## TMS320C82 Errata Sheet

### December 31, 1997 – Version 1.0h

#### 2 Cyc/Col SRAM Read - Rev 1.0/1.1

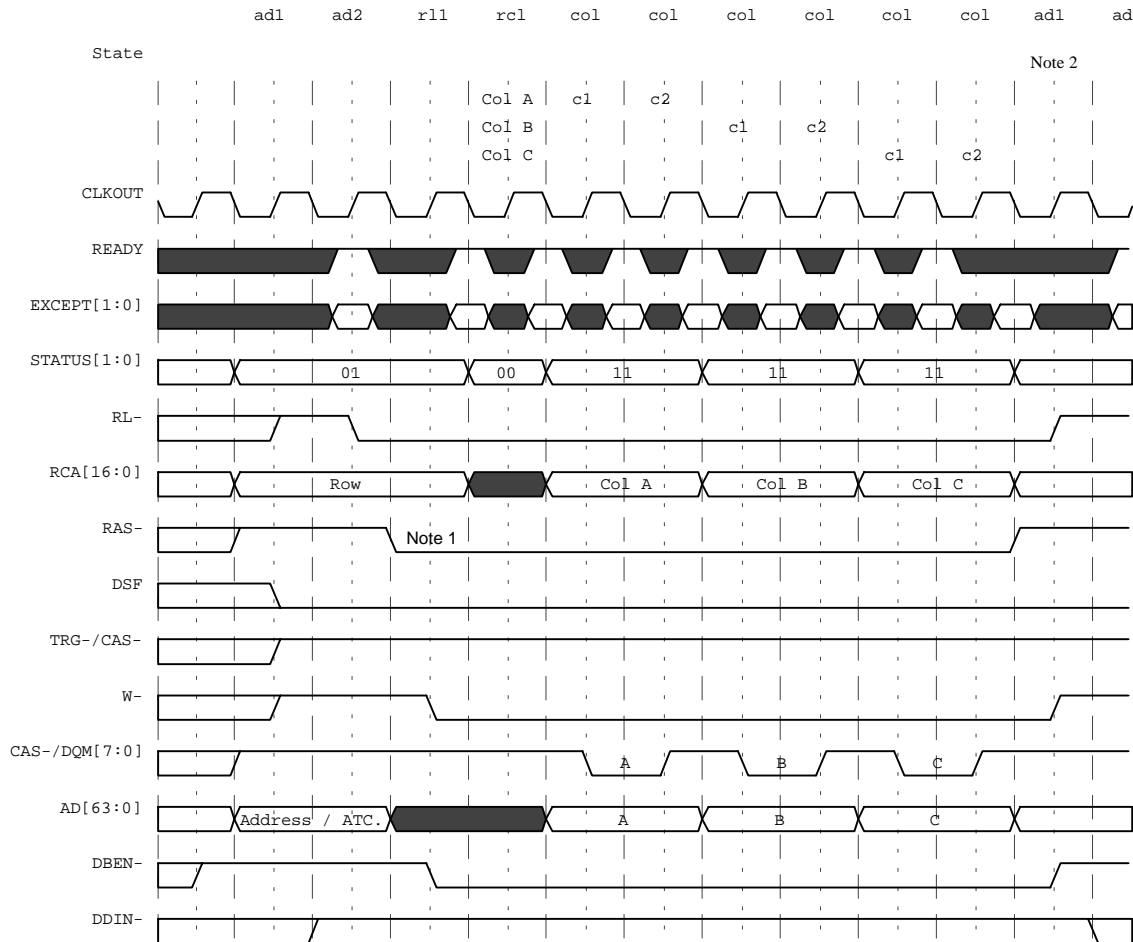
The 2 cycle/column SRAM (CT = 0110) cycles are not implemented correctly. For 2 cycle/column reads, the fall of **/CAS** is delayed by ½ cycle. The following cycle diagram illustrates the operation of revision 1.0/1.1 silicon for 2 cycle/column SRAM reads.

**Workaround:**

None. As a consequence, SRAMs with faster access times may be required to interface at this cycle timing.

2 Cyc/Col SRAM Write - Rev 1.0/1.1

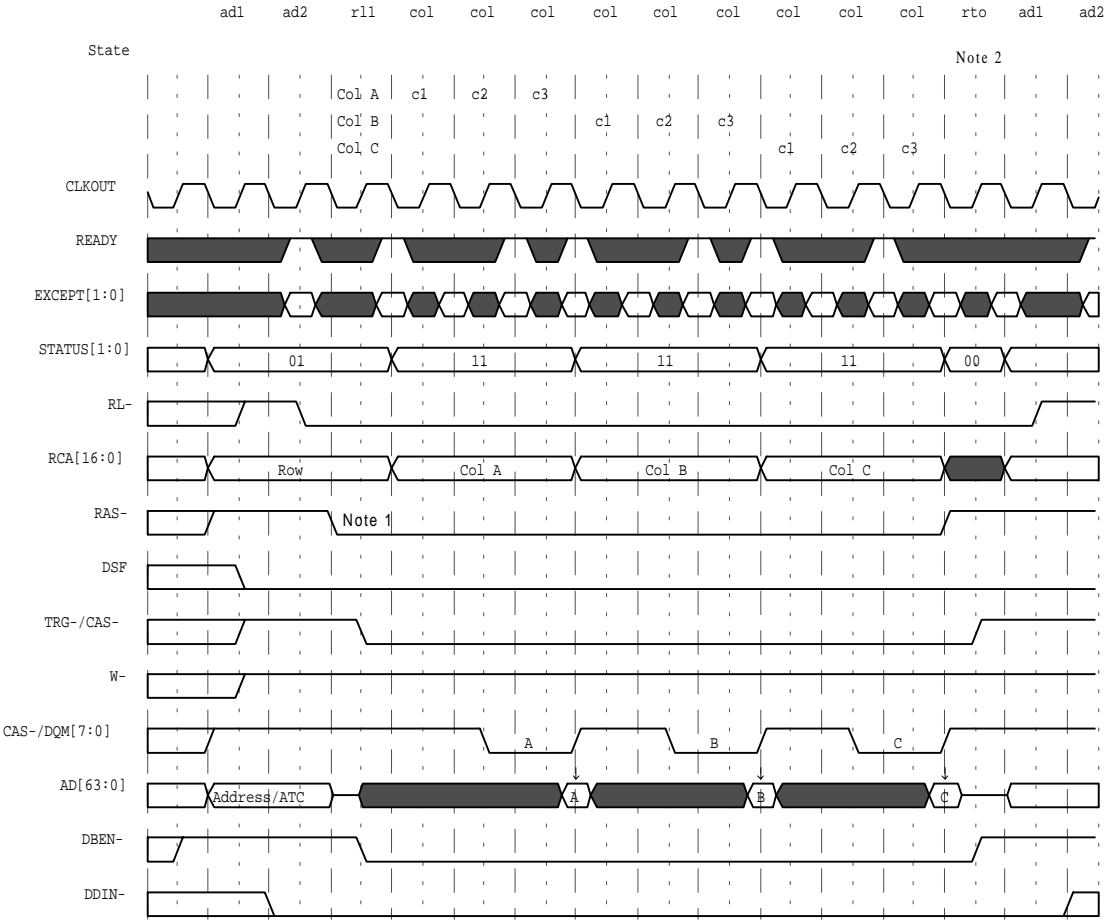
In the revision 1.0/1.1 silicon, the 2 cycle/column SRAM write cycles are implemented as shown below. Note that the fall of /CAS is delayed by 1/2 cycle.

3 Cyc/Col SRAM Read - Rev 1.x

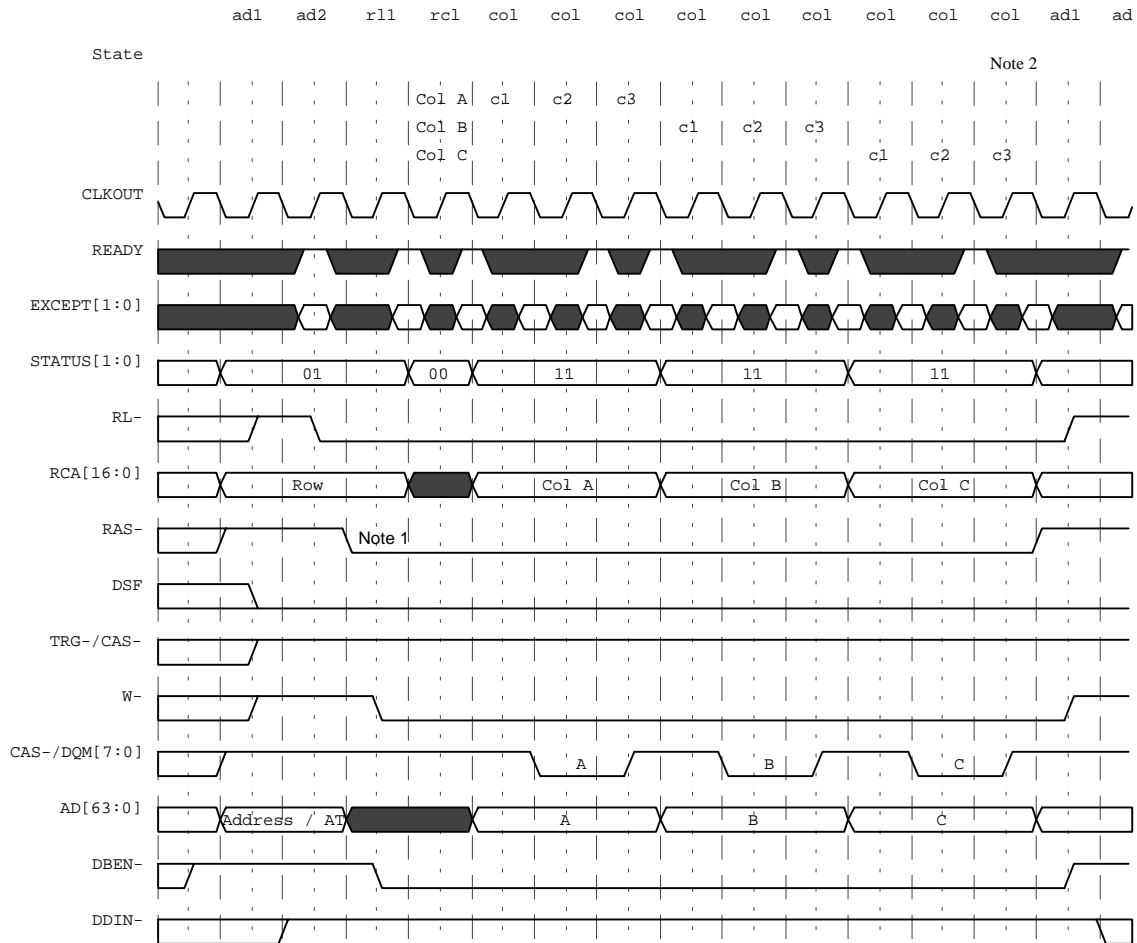
The 3 cycle/column SRAM (CT = 0111) cycles are not implemented correctly. For 3 cycle/column reads, the fall of /CAS is delayed by 1/2 cycle. The following cycle diagram illustrates the operation of revision 1.x silicon for 3 cycle/column SRAM reads.

#### Workaround:

None. For silicon revision 1.3 (see Section 1.12), a 2 cycle/column access (CT = 0110) may be used with the **WS[1:0]** field = 01 to achieve a longer /CAS low pulse width.

### 3 Cyc/Col SRAM Write - Rev 1.x

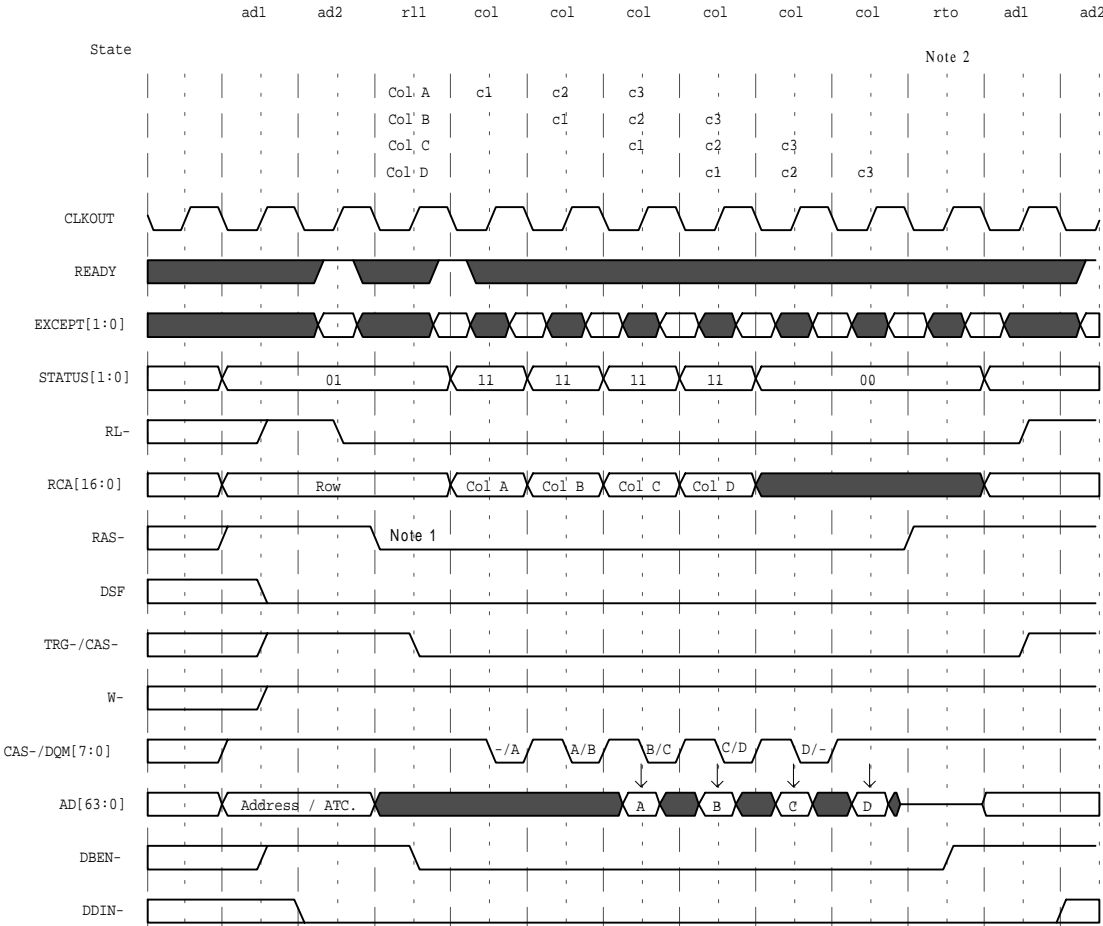
In revision 1.x silicon, the 3 cycle/column SRAM write cycles are implemented as shown below. Note that the fall of /CAS is delayed by ½ cycle.

Synchronous SRAM Read - Rev 1.0/1.1

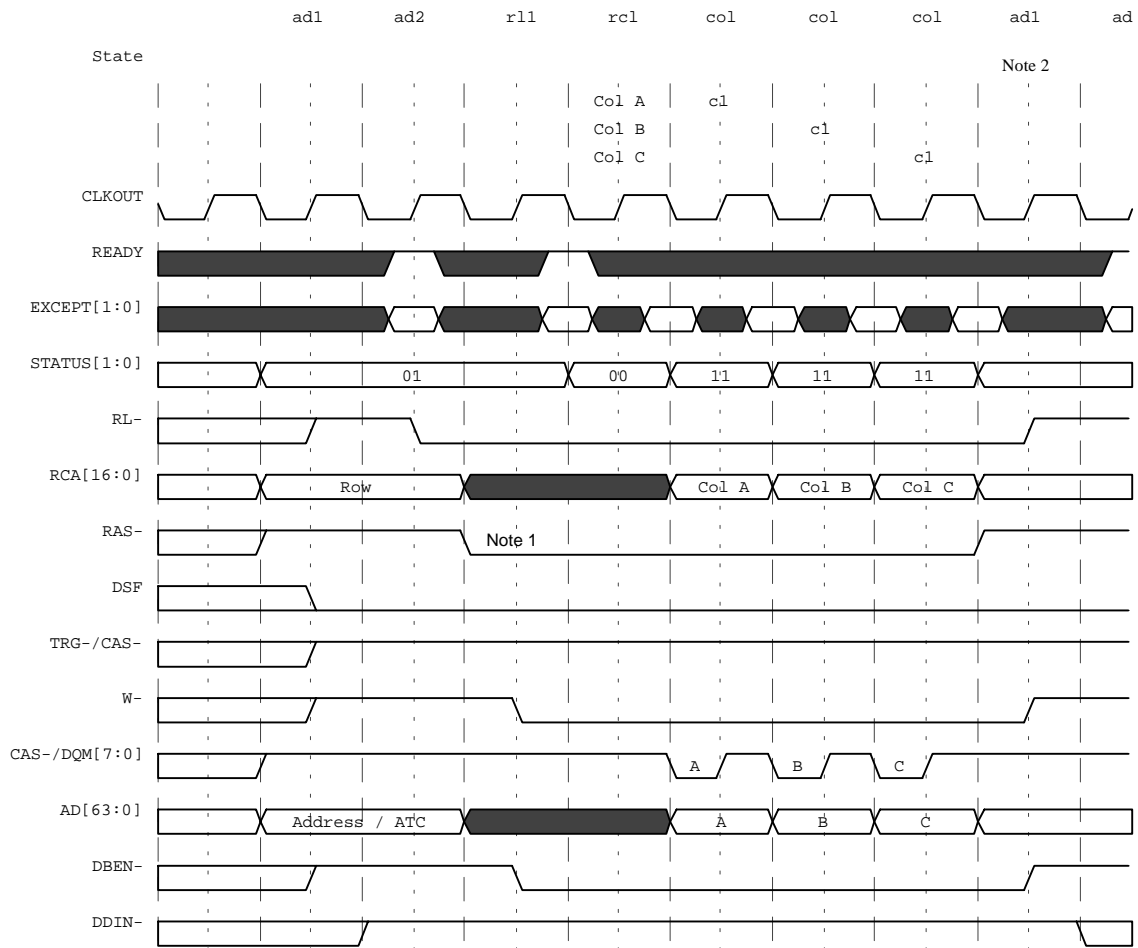
The synchronous SRAM (CT = 0100) cycles are not implemented correctly. In revision 1.0/1.1 devices, the synchronous SRAM reads are implemented as follows. Note that the /CAS signals are active (low) for only 1/2 cycle, and an additional /CAS pulse is inserted to force a drain that is not required.

**Workaround:**  
 None.

**PLL Disabling**

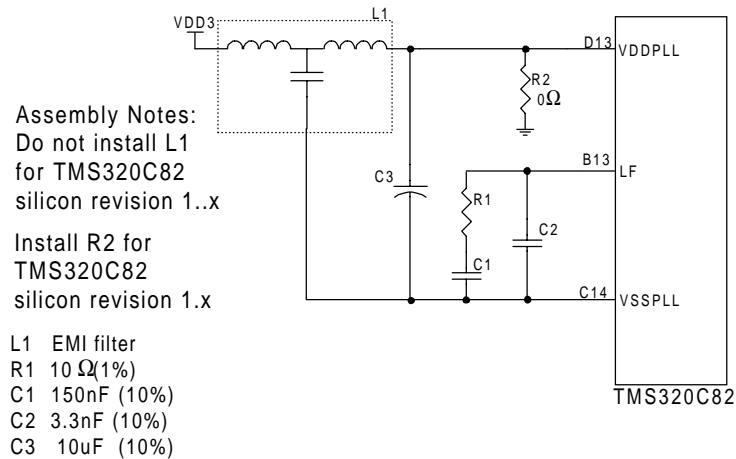
The on-chip phase-locked loop (PLL) of the TMS320C82 exhibits a large amount of jitter in silicon revision 1.0/1.1. The jitter can prevent reliable operation.

Disable the PLL. This can be accomplished by connecting  $V_{DDPLL}$  (D13) to system GND. The following schematic illustrates this.

When  $V_{DDPLL}$  is tied to GND, the device operates in non-PLL mode; **CLKOUT** is  $\frac{1}{2}$  the frequency of **CLKIN**. With the PLL disabled, components R1, C1, C2, and C3 are not required.

**Bank Configuration Cycle - Rev 1.0/1.1**

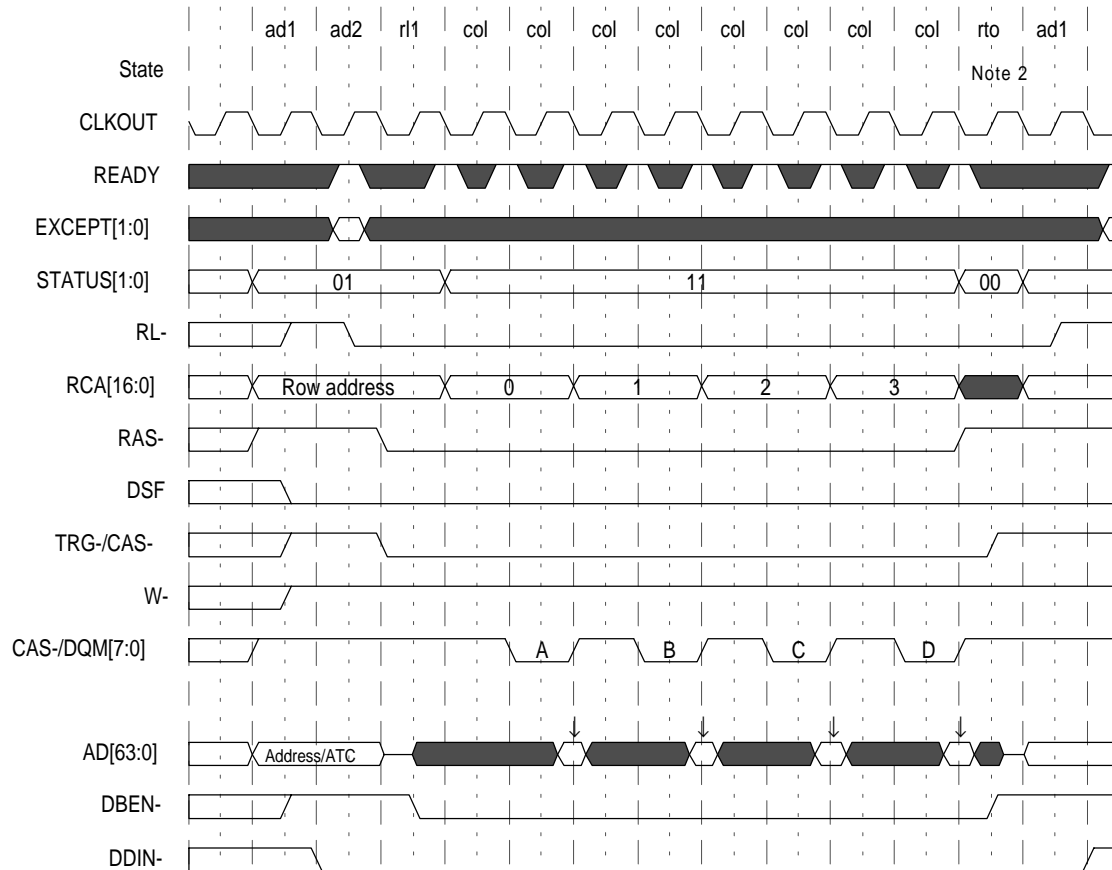
The memory bank configuration cycles are not implemented correctly. Similar to the 2 cycle/column SRAM reads, the fall of **/CAS** is delayed by ½ cycle. The following cycle diagram illustrates the operation of revision 1.0/1.1 silicon for memory bank configuration cycles.

**Workaround:**

None. Devices with faster access times may be needed to provide configuration data if **/CAS** is used as the output enable of said device.

Figure 1.13.1 - Normal Operation

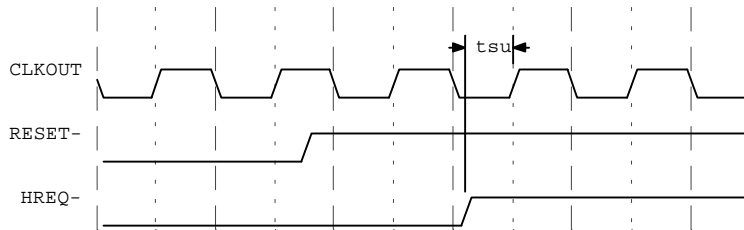
The hold time of the **/HREQ** input with respect to the rising edge of **/RESET** is 0 ns, such that the TMS320C82 may be powered up running by tying **/HREQ** directly to **/RESET**. A bug has been found in the sampling logic of **/HREQ** which will cause the device to hang if the rise of **/HREQ** is sampled low on the second **CLKOUT** cycle after the rise of **/RESET** before the refresh initialization cycles. This is illustrated below.

When the second case is encountered, the TMS320C82 will begin driving all signals normally in the high-impedance state once the host request condition is removed (**/HREQ** pulled high). The device will begin the first refresh cycle normally performed after reset but will then hang. All outputs of the TMS320C82 will continue to be driven, though no signal transitions other than **CLKOUT** will occur.

Ensure that **/HREQ** is sampled high on the second **CLKOUT** rising edge after the rise of **/RESET**. Note that tying **/HREQ** directly to **/RESET** is an acceptable workaround. For multi-C82 designs, it may be required that separate **/RESET** signals be provided for each TMS320C82 to prevent the refresh initialization cycles from conflicting with one another.
